June 11, 1996
LD-96-021

Docket 52-002

Subject: Changes to the System 80+™ Standard Plant Design

Potential System 80+ Design Changes

Figure 5.1.2-3

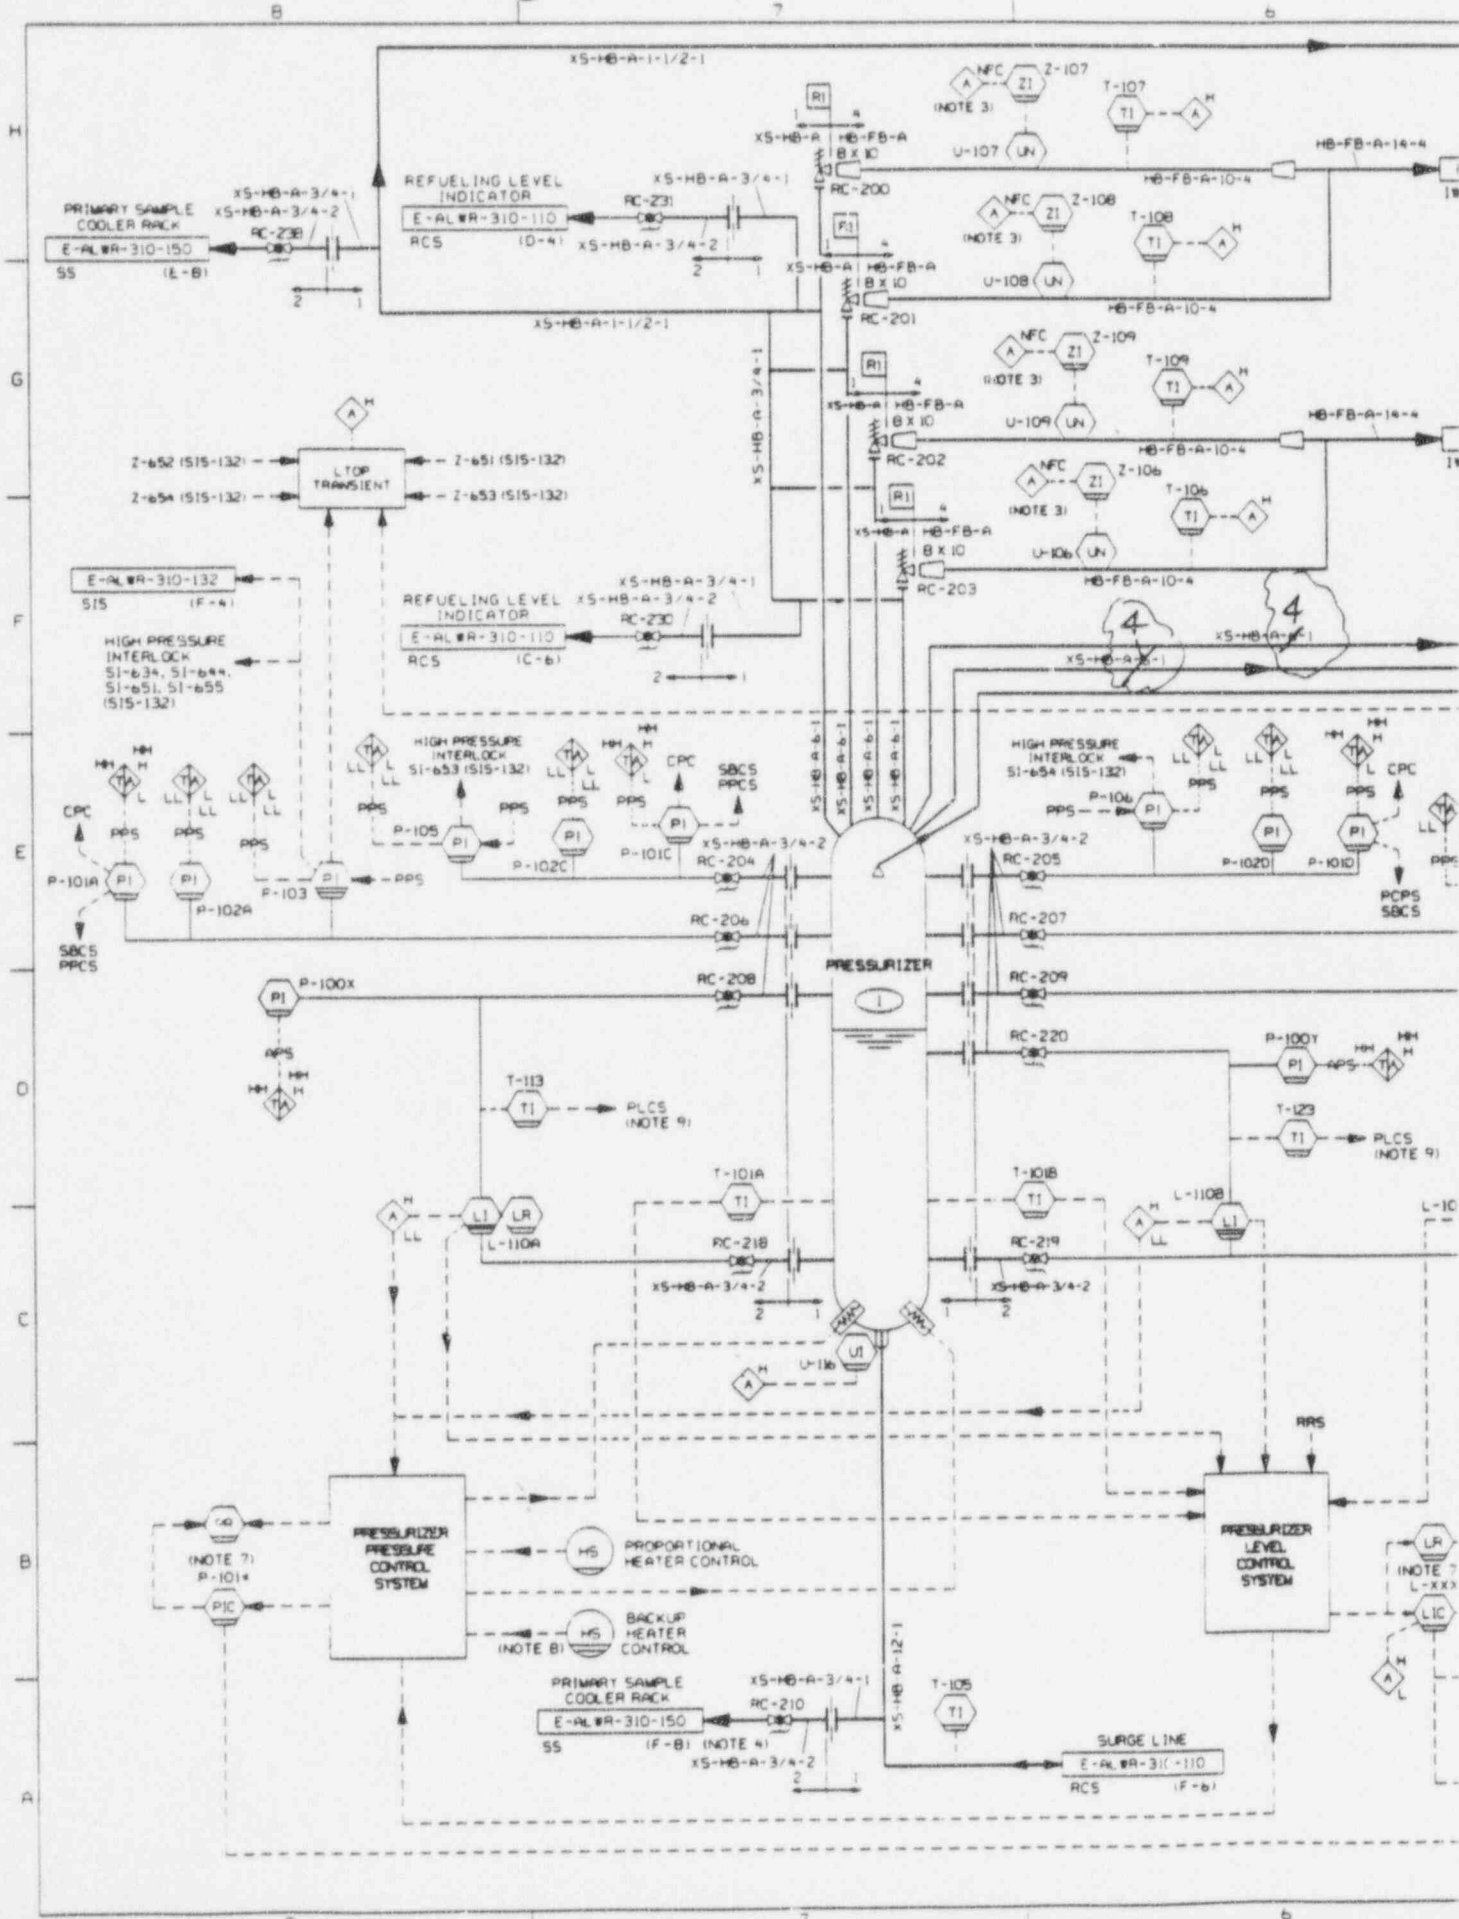
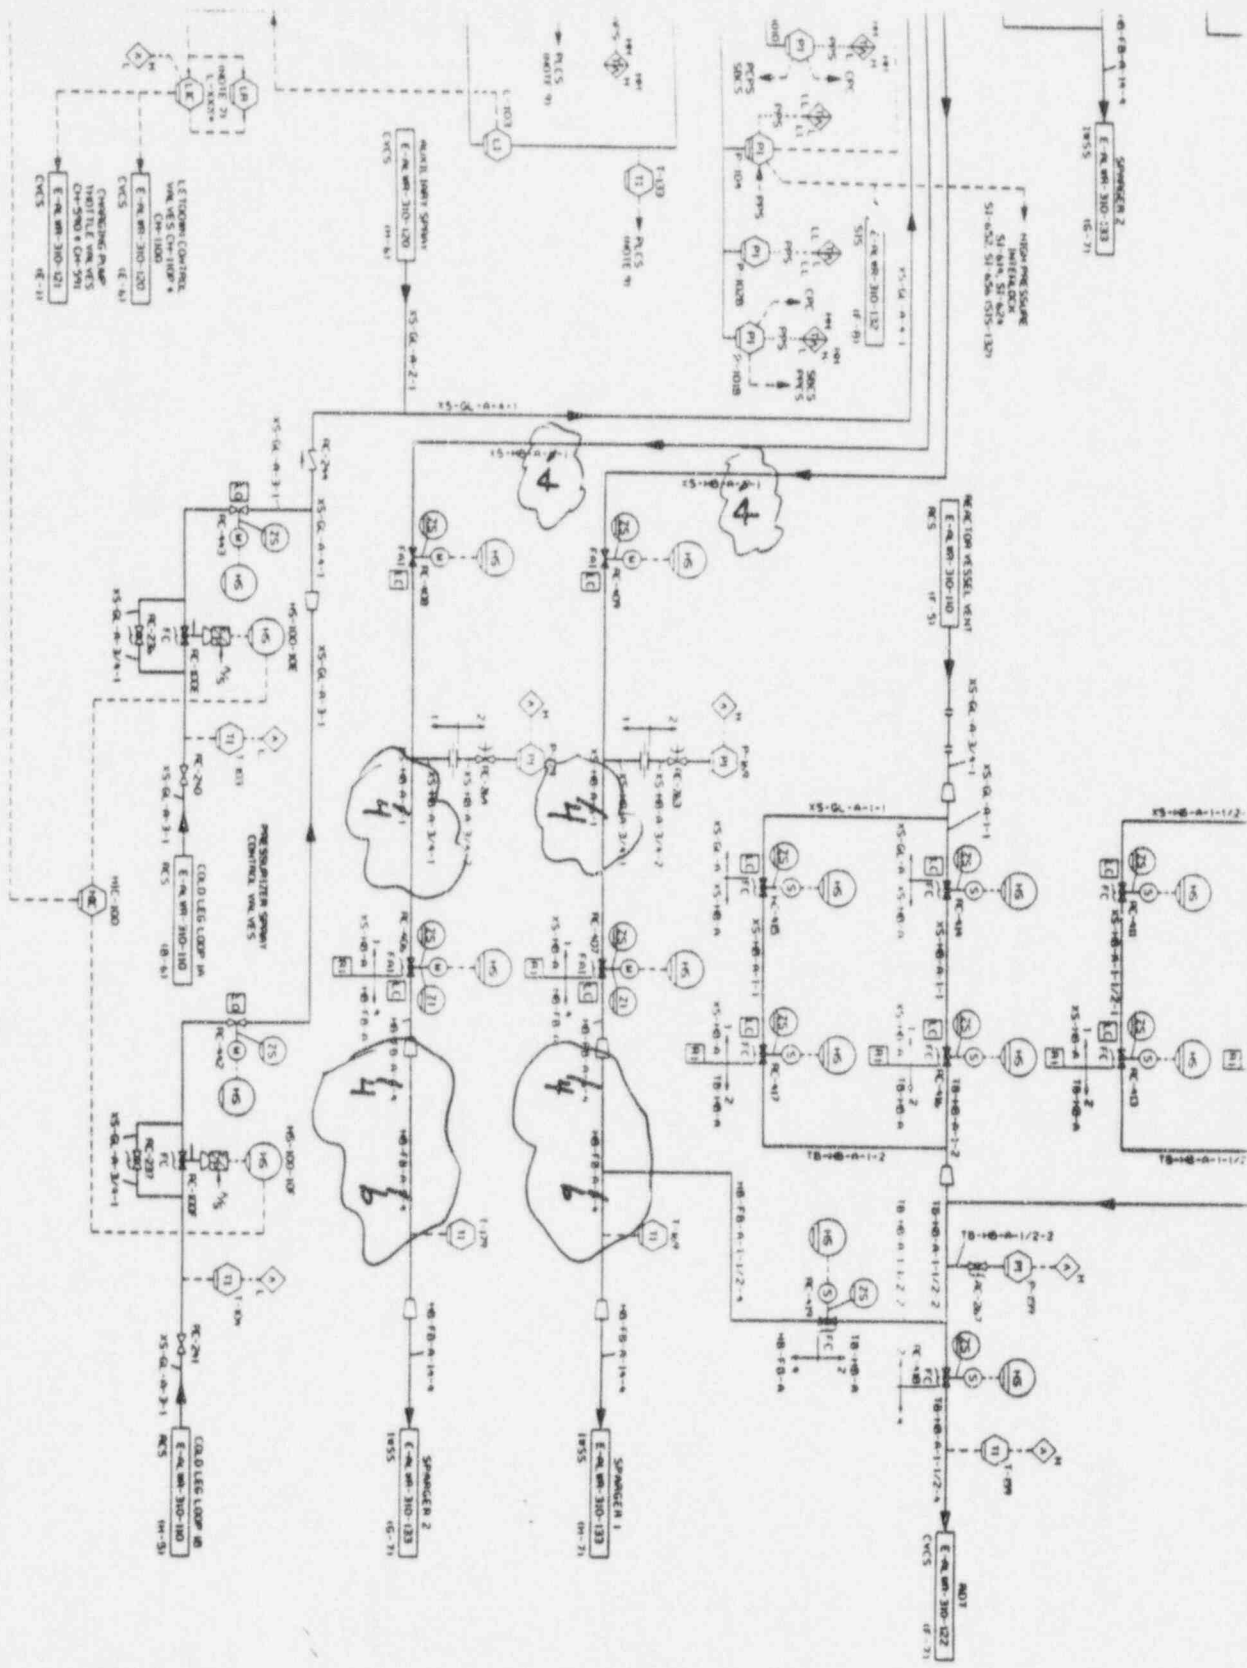
Summary Description: Reduce Safety Depressurization System (SDS) Line Size

Affected DCD Sections: CDM: None
 ADM: Figure 5.1.2-3
 Chapter 6.7
 Chapter 5.4

During the Design Certification engineering, a preliminary design analysis for the SDS line size was performed that showed 6 (six) inch piping and valves would pass more than the minimum flow to meet the EPRI requirements to mitigate a Total Loss of Feedwater (TLOFW) event. During detailed engineering, a more detailed system calculation was performed to determine if 4 (four) inch piping and valves would pass adequate flow. The new analyses confirms that a 4 (four) inch system passes more than enough flow to meet the requirements specified in the DCD (Section 6.7) and preserves the validity of the original TLOFW analysis. This change will revise the RCS/SDS P&ID (DCD Figure 5.1.2-3) to revise the SDS piping and valves from 6 to 4 inches. Modifications to the line and valve sizes are also required in Section 5.4 and 6.7.

Using a four inch SDS system for future System 80+ contracts will allow the use of the same gate and globe valves used for Yonggwang 3 & 4. These valves have been tested and qualified for this service, so proven components would be used and retesting would not be required.

Figure 3.9A-12

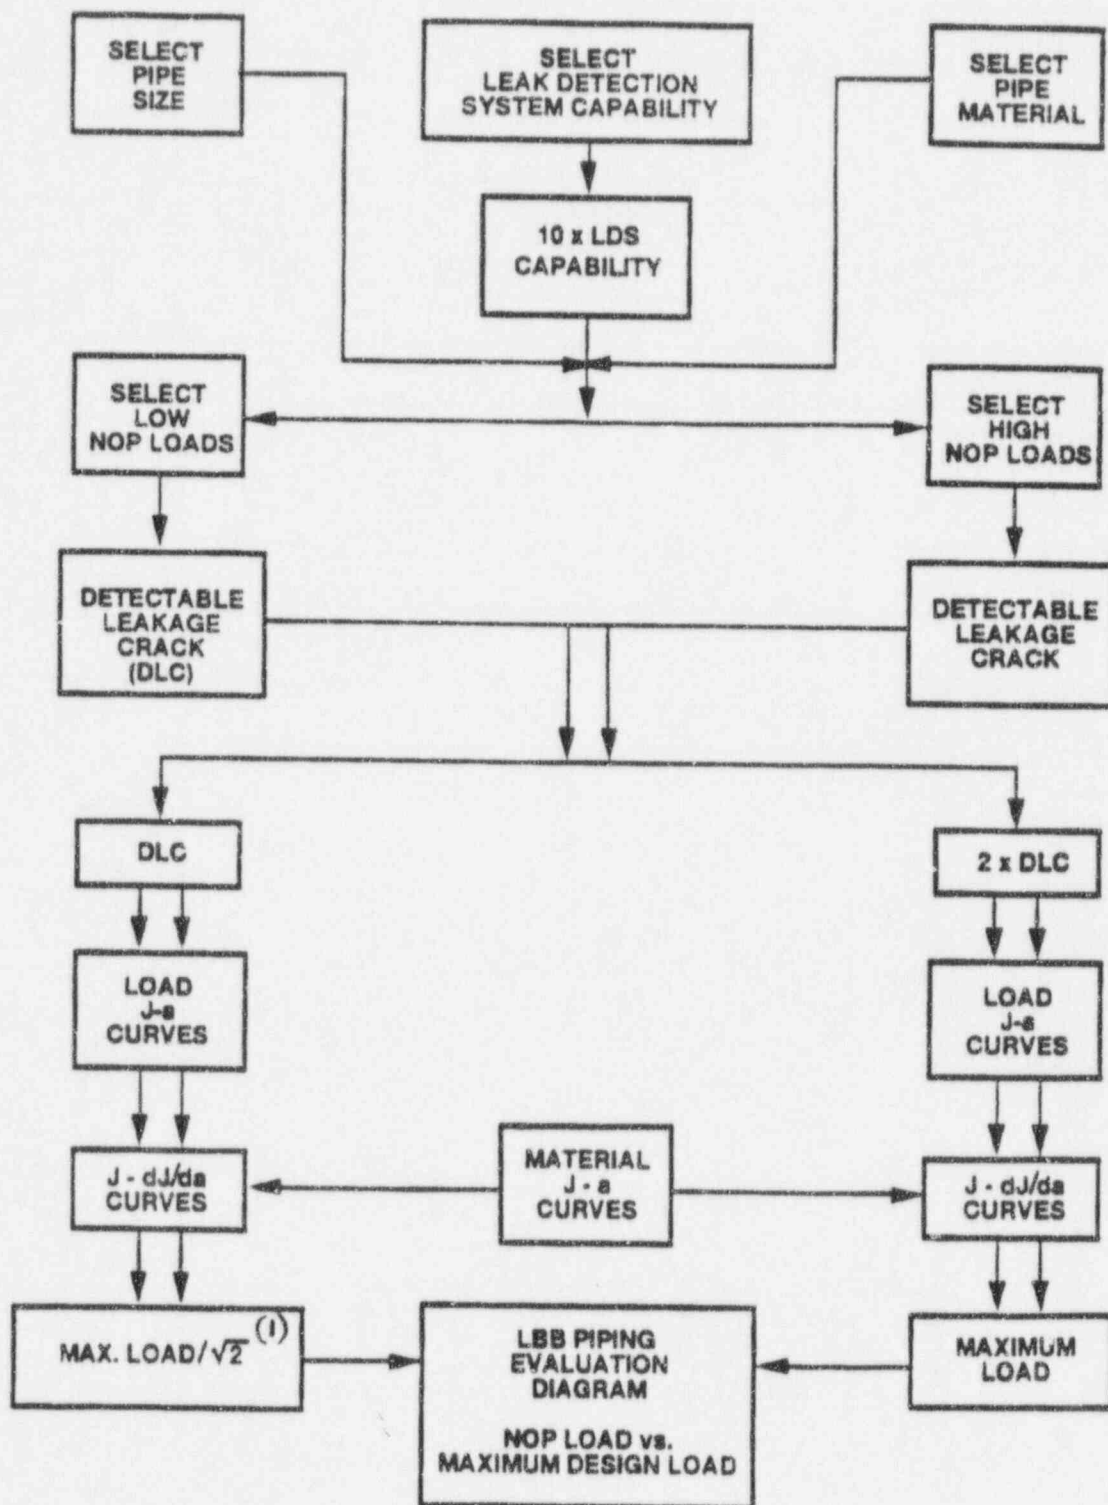
DCD Section: 3.6.3, 3.9A, Figure 3.9A-12

The NRC has approved a change for determining leak-before-break (LBB) crack stability criterion on load. The System 80+ certified crack stability criterion on load was that a pipe with a leakage crack length subject to loads of $\sqrt{2} \times (\text{NOP} + \text{Maximum Design Load})$ was required to have significant margin between the material and loading curves. An alternative stability criterion on load is $1 \times (\text{NOP} + \text{Maximum Design Load})$ when the components of the NOP load as well as the NOP plus Maximum Design loads are combined by the absolute summation method. This criterion was approved by the NRC staff on another ALWR design. The System 80+ DCD will be changed to include this criterion as part of an acceptable alternative method for demonstrating LBB.

Figure 3.7-32		Delete
---------------	--	--------

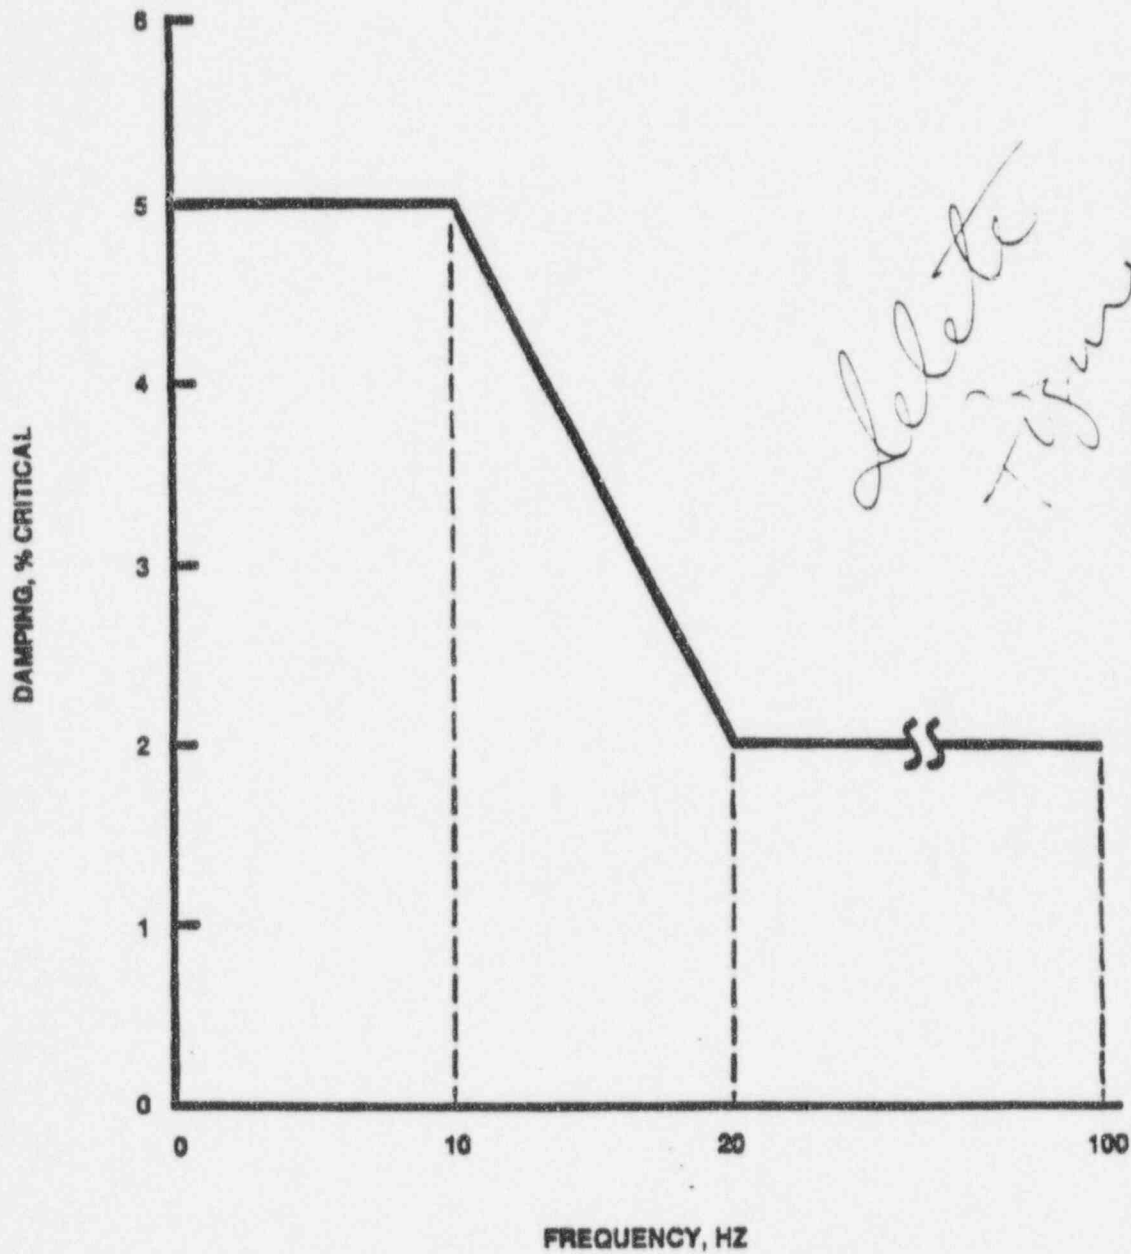
DCD Section: 3.7, Table 3.7-1, Figure 3.7-32

The NRC has approved a change in the maximum allowable value of applied damping for piping analyses in which the uniform envelope response spectrum analysis method is used. The maximum allowable damping in the System 80+ DCD for this type of analysis is currently based on ASME Code Case N-411-1, which allows the damping to vary from 5% for modes of vibration up to and including 10 Hz to 2% for modes above 20 Hz. The NRC approved change allows 5% damping for all modes of vibration when the uniform envelope response spectrum analysis method is used on piping. This change was approved by the NRC staff on another ALWR design.

Table 3.7-1		Add entry for 5% damping, delete Note [2]; renumber Note [3] to [2]. Last 3 entries to Table 3.7.-1 should read as follows:
-------------	--	---

<i>[[Piping (diameter ≤ 12 inches)</i>	<i>2.0</i>
<i>Piping (diameter > 12 inches)</i>	<i>3.0</i>
<i>Piping (uniform envelope response spectrum method of analysis)</i>	<i>5.0]]</i> ^[2]
